## Communication from Public

**Name:** Linda Deacon  
**Date Submitted:** 02/11/2020 11:55 AM  
**Council File No:** 20-0027  
**Comments for Public Posting:** Comment from adjacent neighbor

Subject: Proposed development of 8 lots at 560, 566, 572, 578, 600, 608, 614, and 620 Marquette Street, Pacific Palisades, CA 90272.

**To:** Planning and Land Use Management Committee of the Los Angeles City Council

Figure 1.

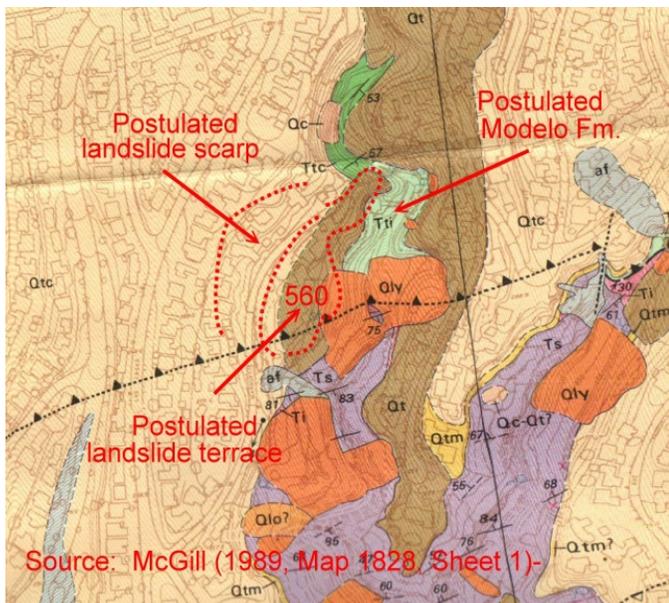
Sulfate oxidation the Modelo Formation is known to have produced jarosite and gypsum, the reactions of which are accompanied by significant expansion. The resulting fracturing leads to a presumption that more massive sections of the Modelo in the Pacific Palisades have failed for that reason rather than the special unstable conditions where slopes undercut well-developed sections of shale to produce bedding-plane slides. However, Eastman (2000, p. 3) notes that the landslide debris underlying 560 “... appears to have developed on an out of slope condition in the bedrock along Pulga Canyon.” This, together with his frequent notations of dips in siltstone in the range of 8 to 28 percent (4.6 – 15.6 degrees from horizontal) in Boring No. 3, and 15 to 18 percent (8.5 – 10.2 degrees from horizontal) in Boring No. 4, suggest that the landslide debris underlying 560 is the result of a bedding-plane failure in siltstones or shales of the Modelo Formation a section of which is shown by McGill nearby overlying the Sespe Formation shown in Figure 1 (*supra*.)
